STEAD PARK COMMUNITY CENTER

Updates from Approved Concept Review

CFA Approved Concept Review

Design Responses for CFA Final Review

DETAILING AND CONNECTIONS AT SOLAR CANOPY & HISTORIC BUILDING

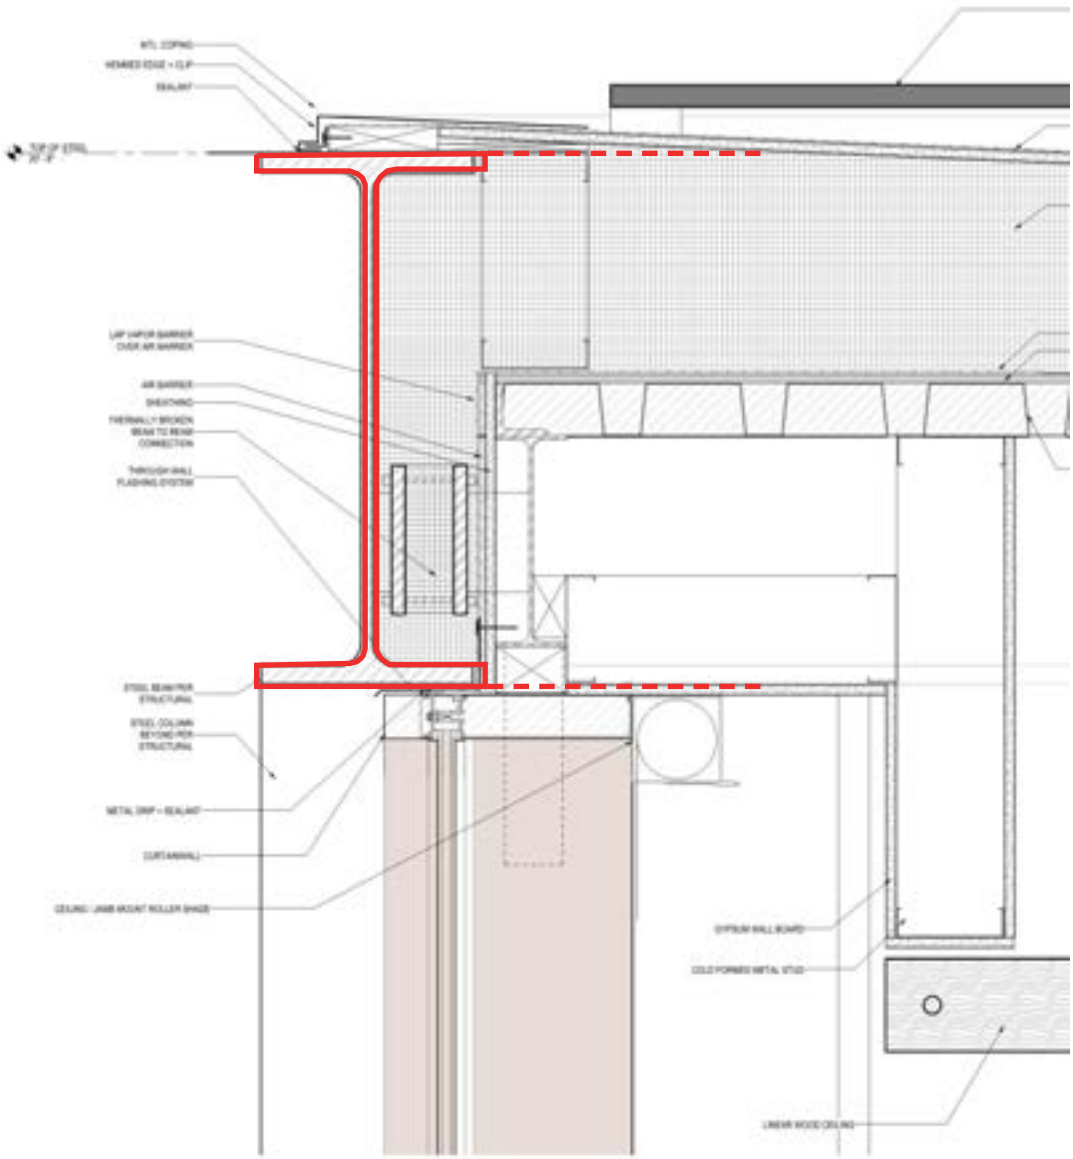
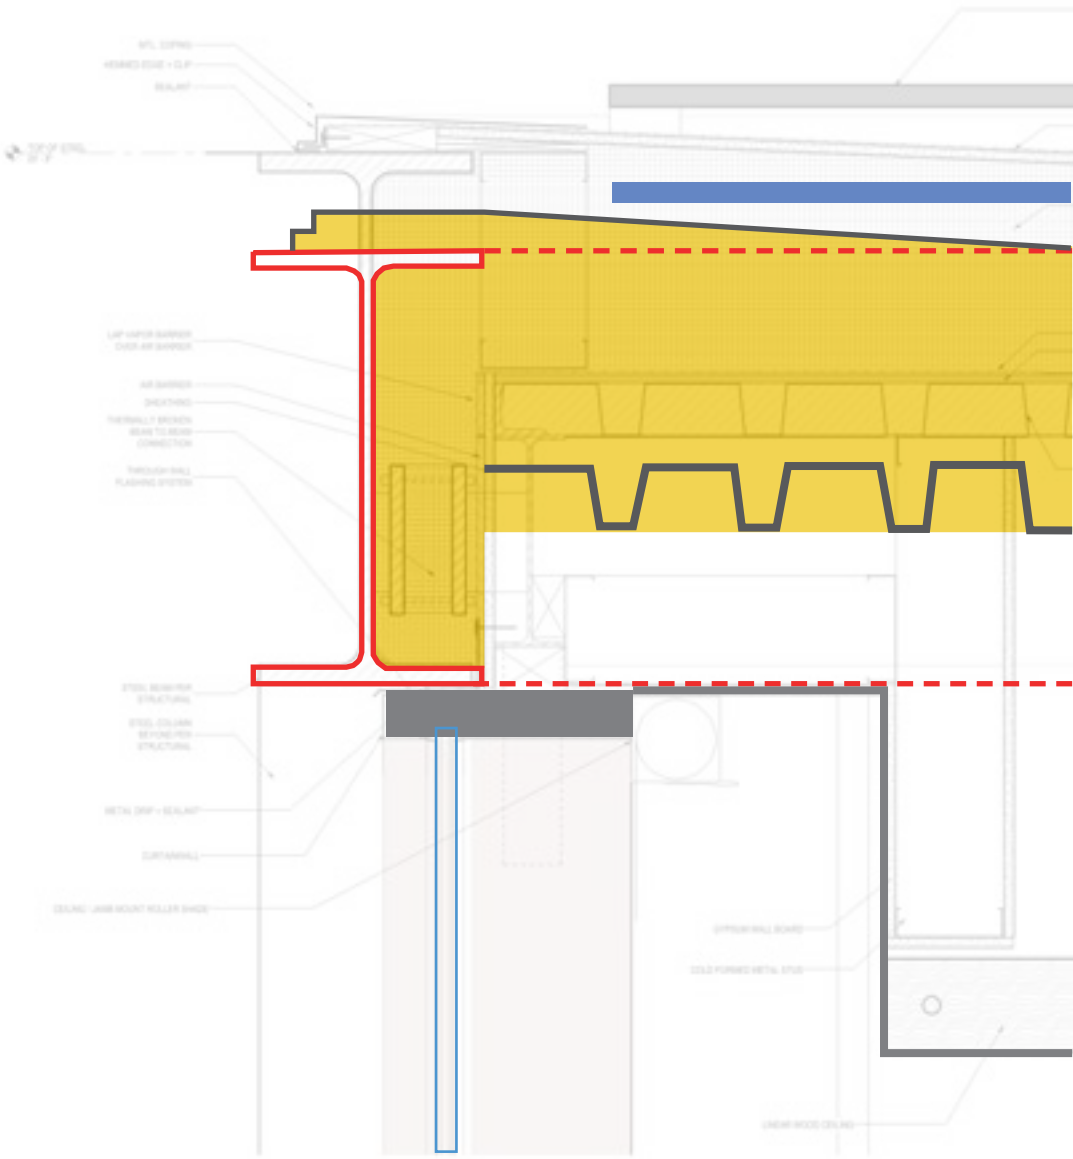
Key Details at Solar Canopy and Connections: CFA advised that as the design is developed, the skillful treatment of several details would be important, including: the profile of the pavilion columns, as well as their intersection with the new brick walls and the ground plane; the detailing, bird-proofing, and maintenance of the solar panels; and the way the new construction would engage the historic brick facades.

CONCEPT DESIGN
W14X159 COLUMNS : 15" X 15"
W30X173 BEAMS : 30.4" DEEP X 15" WIDE

REVISED DESIGN
W14X61 COLUMNS : 13.89" X 9.95"
W24X131 BEAMS N/S : 24.48" DEEP X 12.855" WIDE
W24X68 BEAMS E/W : 23.73" DEEP X 8.965" WIDE

→ **Key Details & Connections at Solar Canopy:** The design team has developed details of the architecturally exposed structural steel to express the consistent W-shaped beams and columns for the solar canopy. Beams and columns have been calibrated so that the flange of the beams aligns with the width of the columns in both orientations. Due to the ultimate PPA arrangement, the design team has developed requirements and coordinated the future installation to integrate the panels into the canopy structure and minimize the visual impact of conduit, electrical equipment, and supporting substructure.

HYPHEN OPTIONS

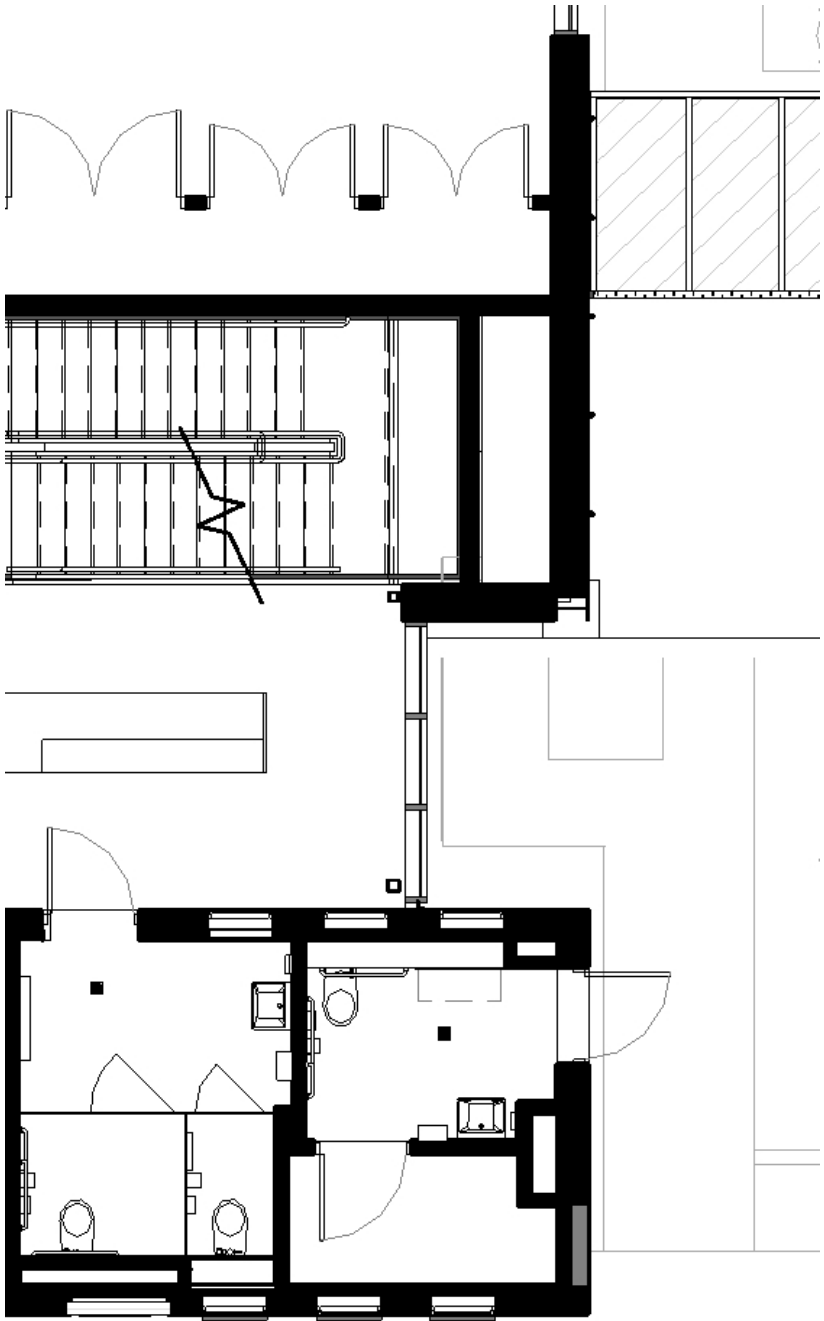
Hyphen: CFA expressed support for a design that would provide glazing, as shown in Options #1 and #4.

→ **Hyphen:** The design team has developed the hyphen element to be all glazing.

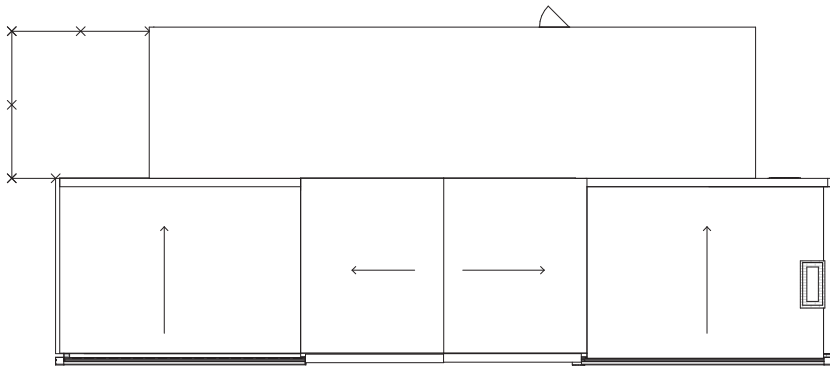
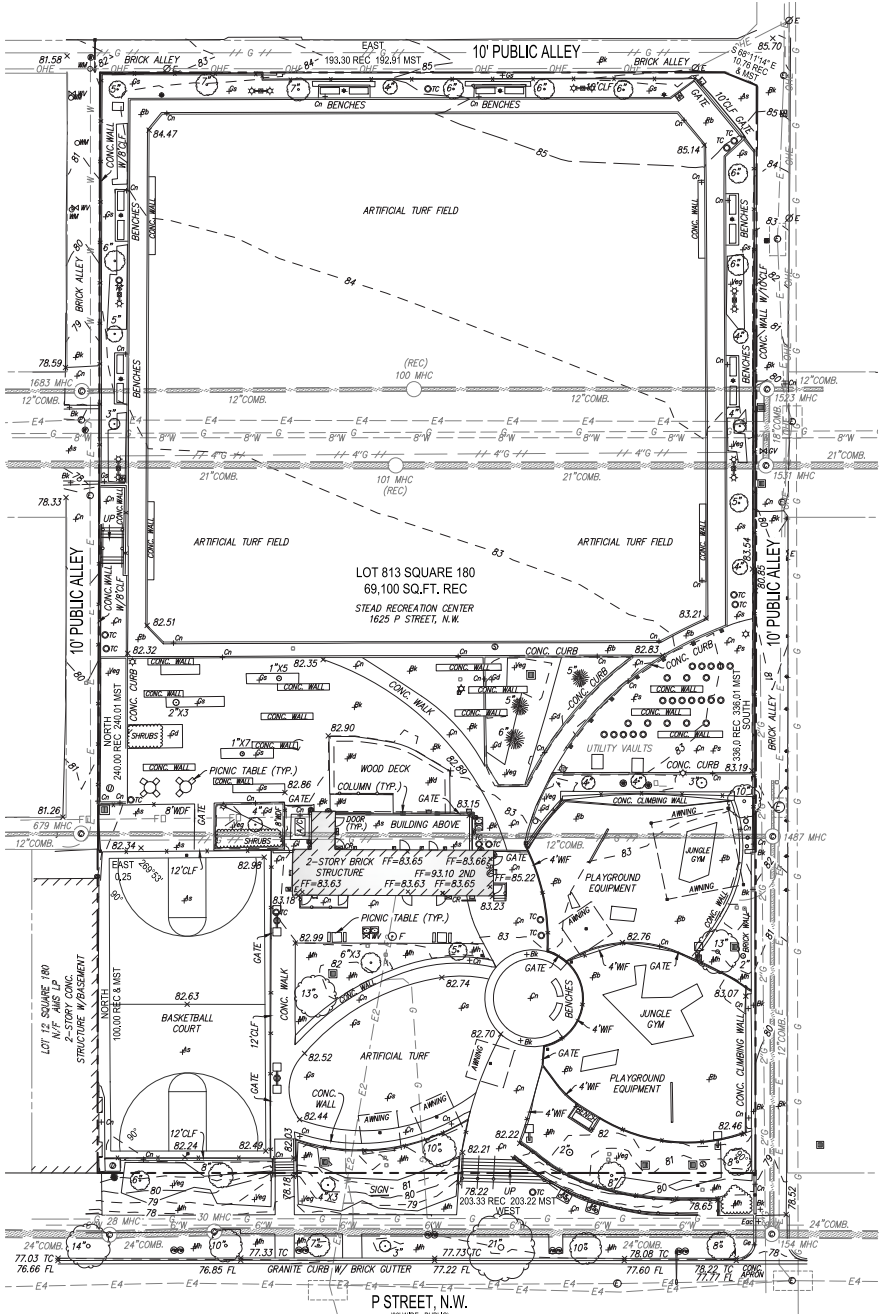
Treatment of the Historic Carriage House: CFA encouraged development of a design that retains the existing historic elements—the Queen Anne-style pediment and the steel support beam—as shown in Options #1 and #2. They commented that Option #1 would provide a visual connection and sense of transparency between the old and new structures due to their matching colors and materials. For either option, they suggested that the pattern of vertical infill elements align between the first and second levels, preferably centered on the rosette details on the historic beam.

→ **Treatment of the Historic Carriage House:** The design team has engaged a historic masonry and envelope consultant (WDP) to provide testing and analysis of the existing historic masonry and mortar. WDP has provided specifications for cleaning (including paint removal), repair, and re-pointing of the historic masonry. The historic masonry will be restored to its original appearance. The original Queen Anne style pediment and steel support beam will also be restored and repainted. On the south facade, the vertical components of the infill glazing have been aligned with the existing rosettes on both the mezzanine and park levels.
